The comments in green were made by Kendra Hanagami, and can be contacted at khanagam@auroragov.org

TARAHUMARA SUBDIVISION FILING NO. 1

COVER SHEET
2260 ANDES WAY

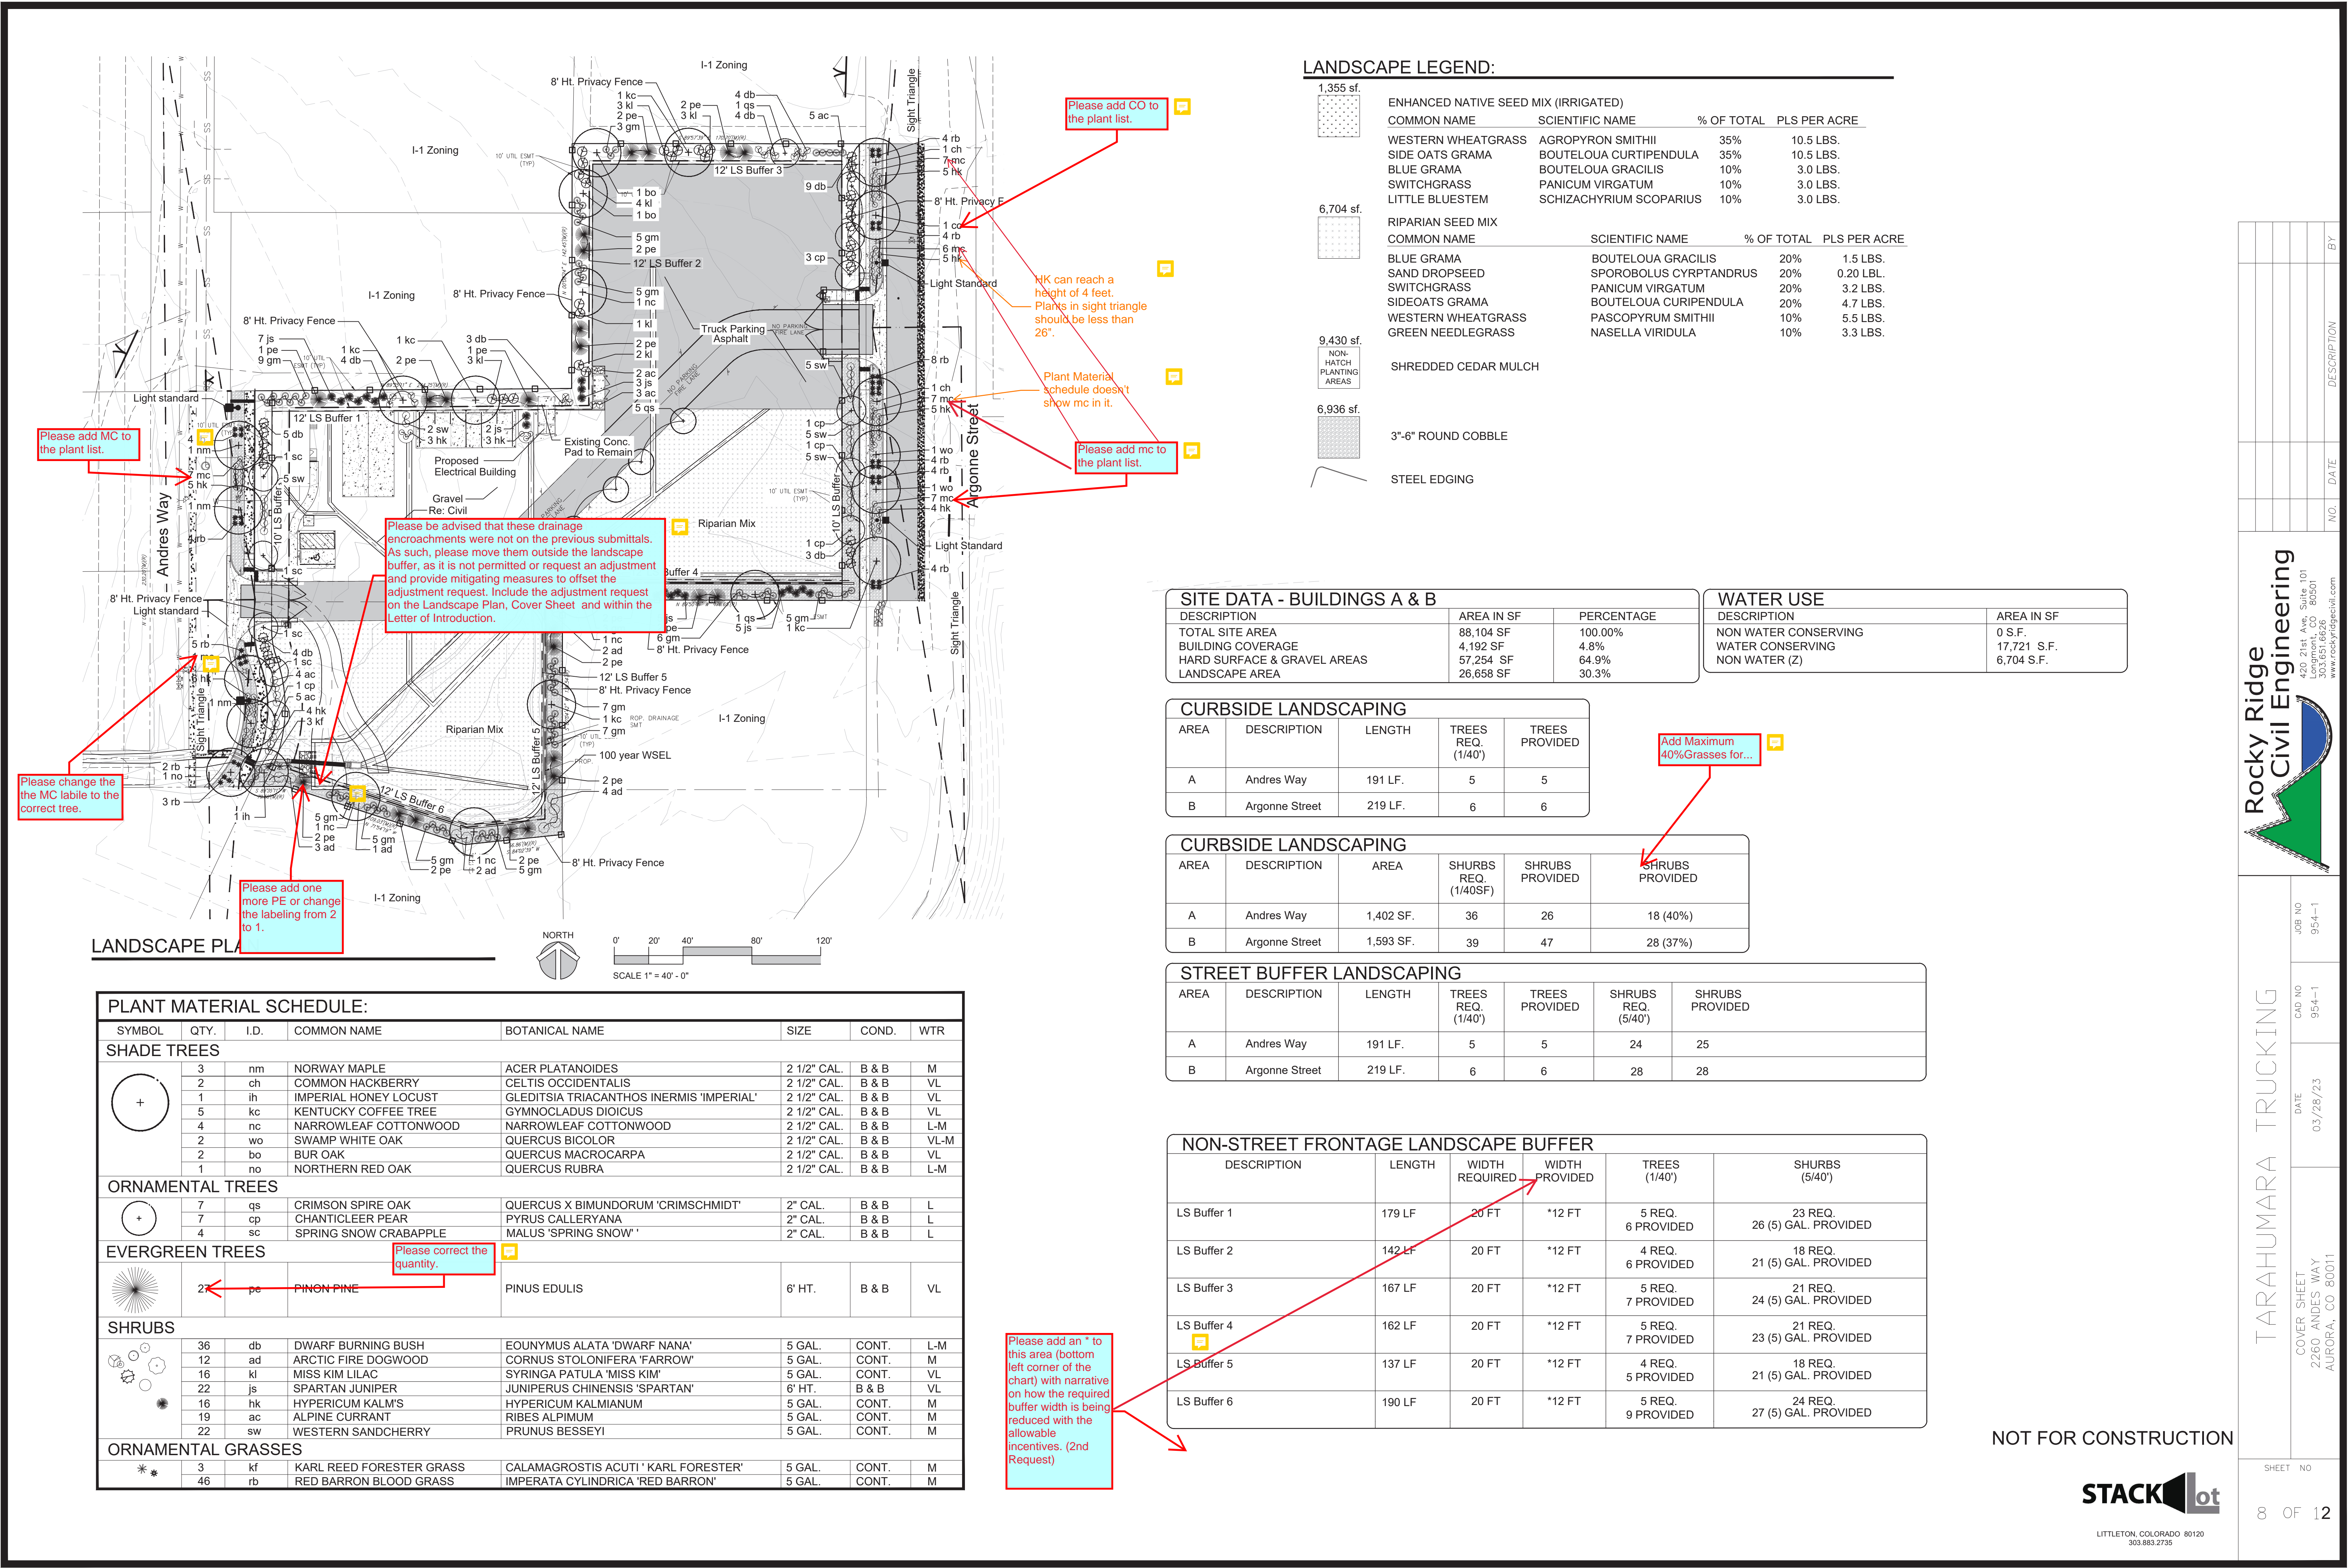
Please add an * to this area (bottom left corner of the chart) with narrative on how the required buffer width is being reduced with the allowable incentives. (2nd Request)
